Westinghouse
Electric Corporation

NS-TMA-2312

Subject: Review of WCAP-9292

Enclosed are fifty (50) copies of responses to NRC questions on WCAP-9292 entitled "Dynamic Fracture Toughness of ASME SA 508 Class 2a and ASME SA 533 Grade A Class 2 Base and Heat Affected Zone Material and Applicable Weld Metals." The enclosed (non-proprietary) information is being provided in response to the Materials Engineering Branch request for additional information received via the July 25, 1979, letter from J. F. Stolz (NRC) to T. M. Anderson (Westinghouse).

FIGURE 120.2-1
Steam Generator Tubesheet

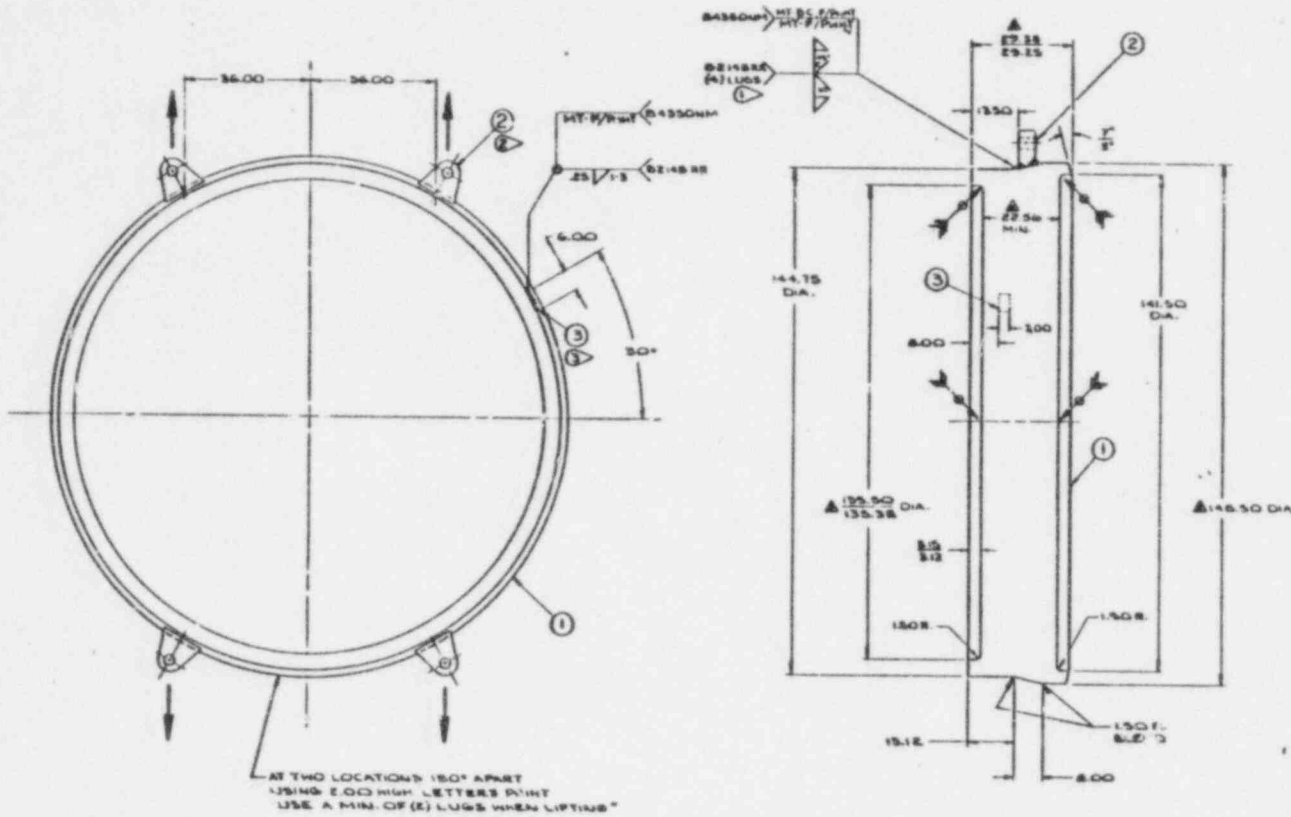
(a) Present the details of typical material histories for the subject steels. The histories should include the as received metallurgical condition and all significant fabrication steps (e.g., type and degree of working, heat treatment time and temperature, welding process description, final product dimensions). Confirm that the steels will be used in the above stated conditions in all applications. If there are exceptions indicate what the exceptions are and what operating plants or plants under construction are affected.

Final dimensions are supplied to each customer via "as built drawings." Typical product dimensions of the steam generator tubesheet, support ring, primary nozzle, primary manway, channel head, and the pressurizer nozzles, manway, head, and shell are shown in Figures 120.2-1 through 120.2-10, respectively.

SA 508 Class 2a Base Material Test Specimen Layout

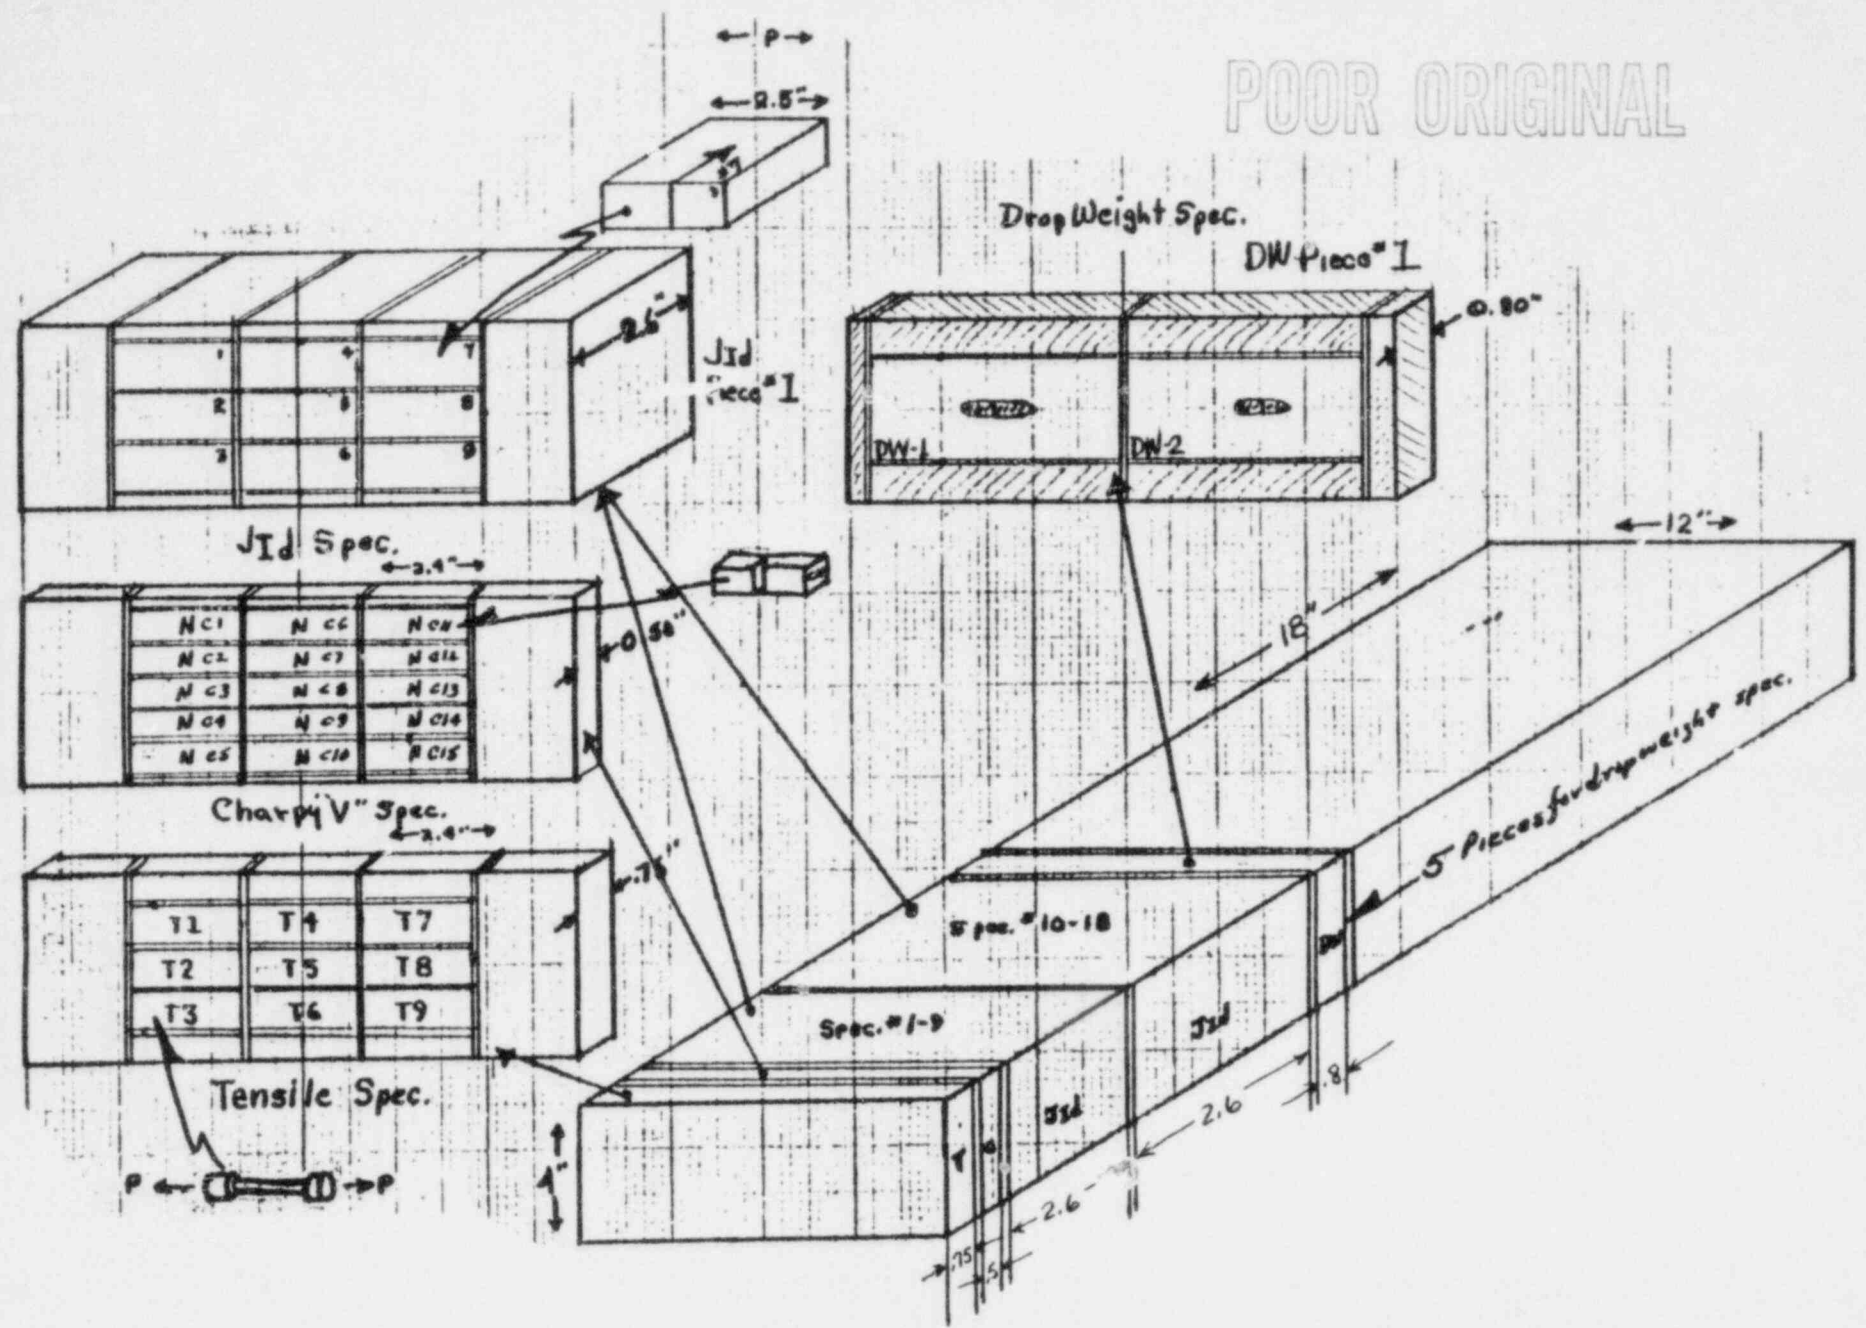
(b) Present the details of the test specimen history for the subject steels. The history should include specimen origin (material, form, size and metallurgical condition), location and orientation of the specimens in the original product, degree of working, and heat treatment time and temperature.

To represent the large range of thicknesses [noted in part (a)], SA 508 Class 2a test forgings were obtained from two of the vendors, which supply production forgings; the test forging thickness selected was 4 inches. The forged SA 508 Class 2a base plates measured 4x12x36 inches. The test specimen layouts for the SA 508 Class 2a base material and heat affected zone (HAZ) material are shown in Figures 120.2-11 and 120.2-12, respectively.

FIGURE 120.4-1 - Fracture toughness versus $T - RT_{NDT}$ for SA 508 Cl 2a base material

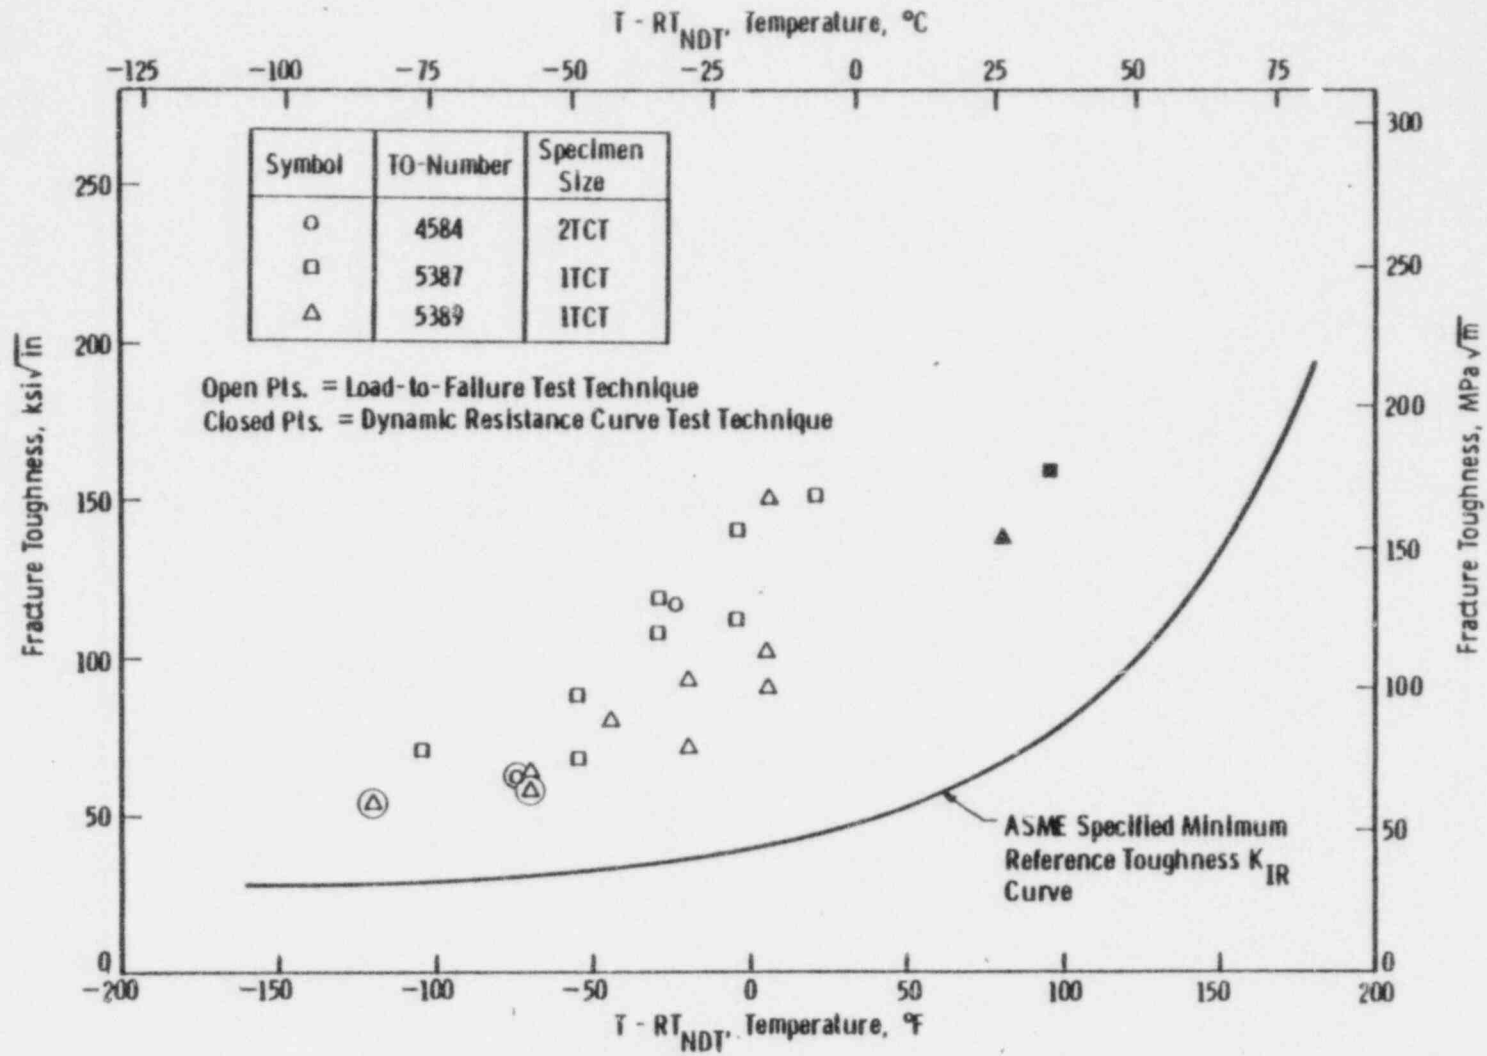
(a) In Section 4-A of the report it is stated that at low temperatures (below the transition temperature) the material fracture toughness was calculated directly from the failure load, as outlined in ASTM E-399-74. However, it is also stated that in some cases the specified size criterion was not met by the one inch thick CT specimens. Identify all of the test results that did not meet the E-399-74 size criterion.

(b) For all other tests (those conducted above the transition temperature) identify the criterion that was used to determine the validity of the test and provide technical justification for using this criterion. Identify all of the test results that did not meet this criterion.

Provide technical justification for the inclusion of any results in this report that did not meet the test validity criteria.

Response: (a) The ASTM E-399 size criterion requires that the specimen crack length (a) and thickness (B) be greater than 2.5 times the conditional fracture toughness divided by the material's yield strength as shown below

In Figures 120.4-1 through 120.4-4, the dynamic fracture toughness data points, which meet the ASTM E-399 size criterion, are circled. In determining which specimens meet this validity criterion, the specimen thickness was deemed the primary specimen dimension and the static yield strength was utilized in the calculations. Employing the static, rather than dynamic, yield strength is conservative and produces the minimum possible number of valid tests. As shown in Figures 120.4-1 through 120.4-4, six SA 508 Class 2a specimens and 12 SA 533 Grade A Class 2 specimens satisfied the ASTM E-399 size criterion; of the 12 SA 533 Grade A Class 2 specimens, only two were base metal tests. It should be noted that little advantage results from testing the substantially larger three inch thick compact tension specimens.

FIGURE 120.5-1
Load-Displacement Records

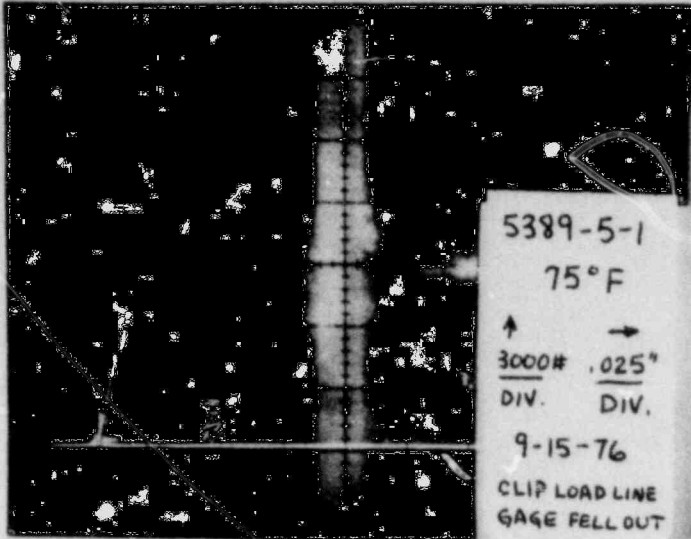
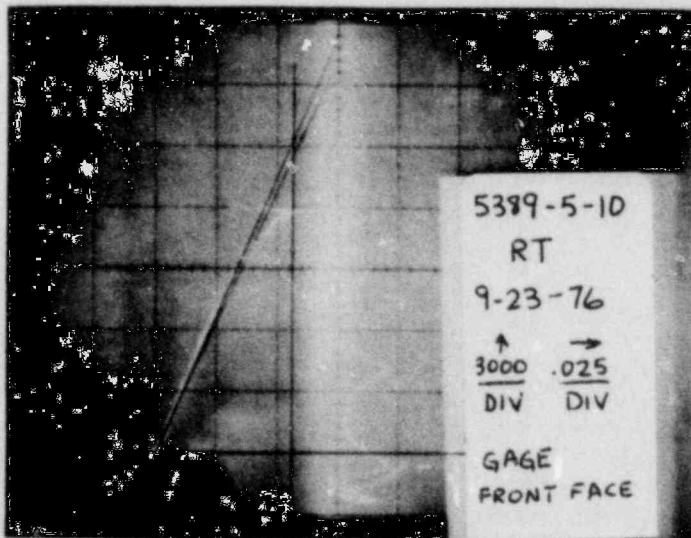
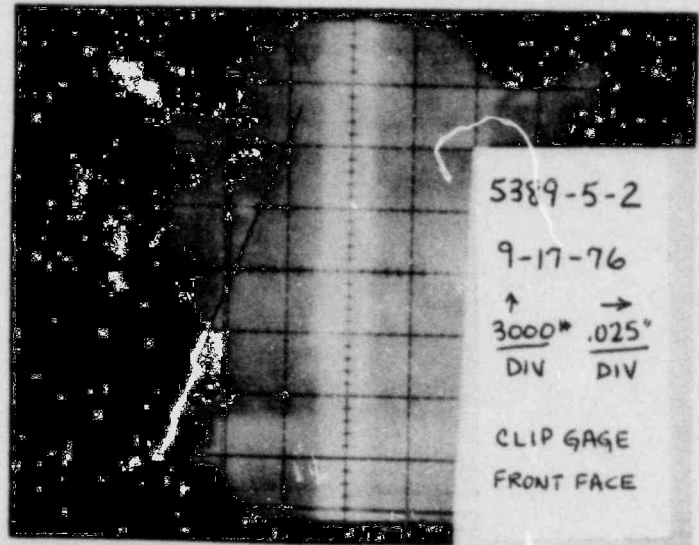
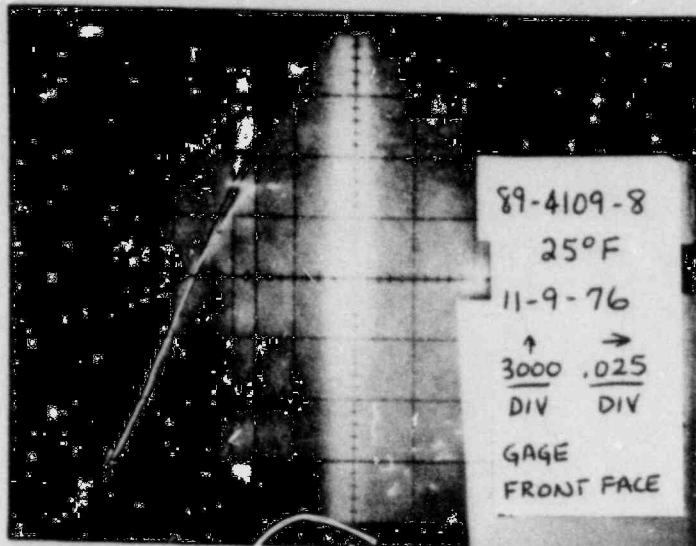
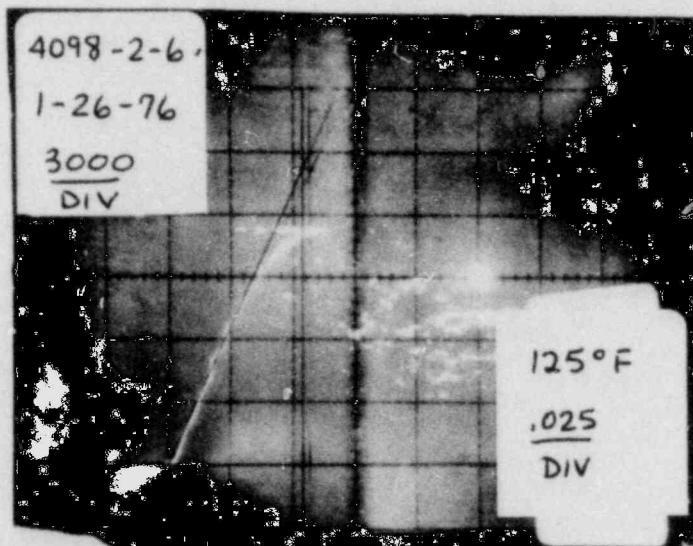
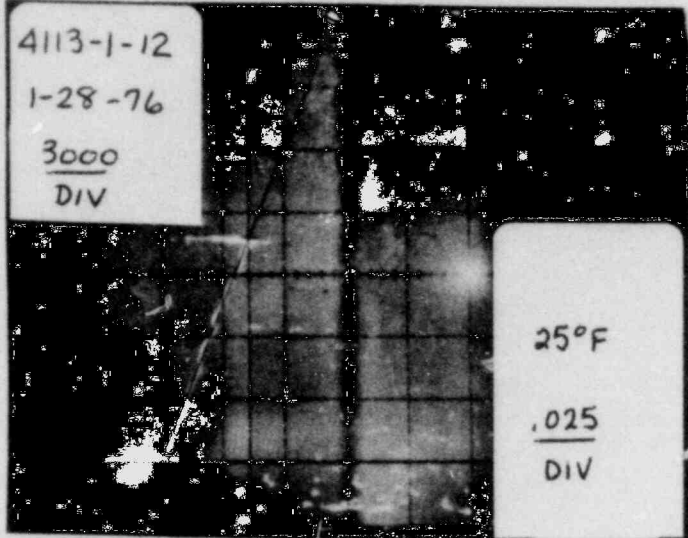
In order that we may verify the test results of this report, supply the load versus displacement curves for the following tests:

<u>Reference Figure No.</u>	<u>Material</u>	<u>TO-Material/TO-Weld</u>	<u>Test Temperature</u>
5-1	508-2a	5389	75°F
5-2	508-2a HAZ	5389/4109	25
6-1	533-2	2864	50
6-2	533-2 HAZ	4336/4113	25
6-2	533-2 Weld	4335/4098	125

Also provide a sample calculation of the J and K values for one of these tests.

Response: Load-displacement records for the tests reflected in Figures 5-1, 5-2, and 6-2 of WCAP-9292 are given in Figure 120.5-1. Note that the load-displacement record corresponding to Figure 6-1 of WCAP-9292 is not available.

Table 120.4-1 (in the Response to Question 120.4) includes the formula for calculation of K or J values.
